MANDATORY SERVICE BULLETIN Z142/54a - Attachment No.1

Root part of strengthened wing

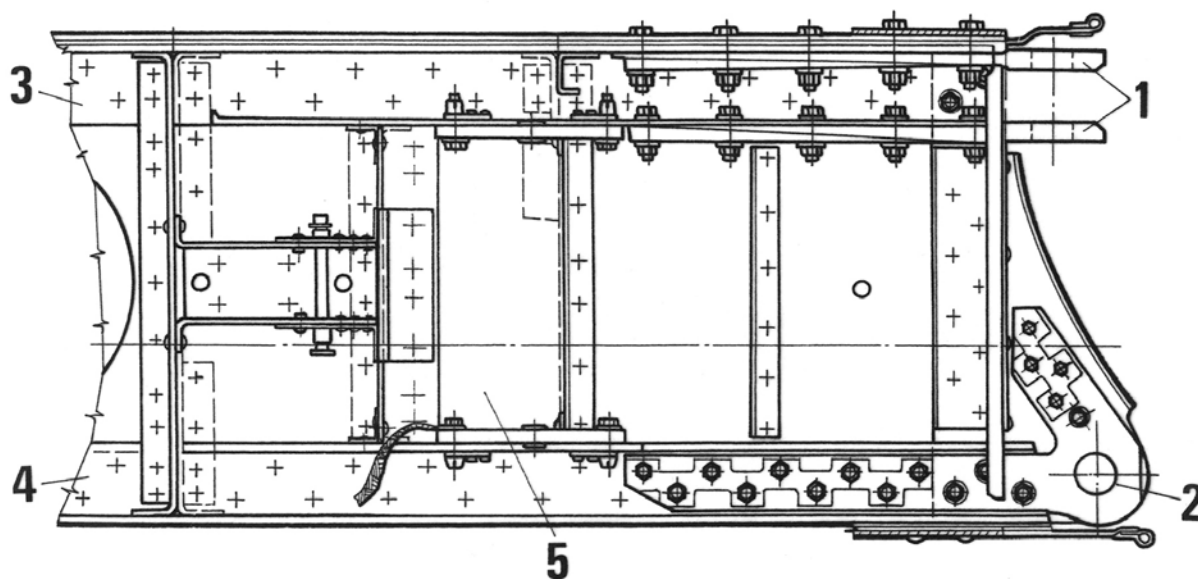
- pos. 1: upper main wing hinges
- pos. 2: lower main wing hinges
- pos. 3: upper main wing spar flange
- pos. 4: lower main wing spar flange
- pos. 5: main wing spar web
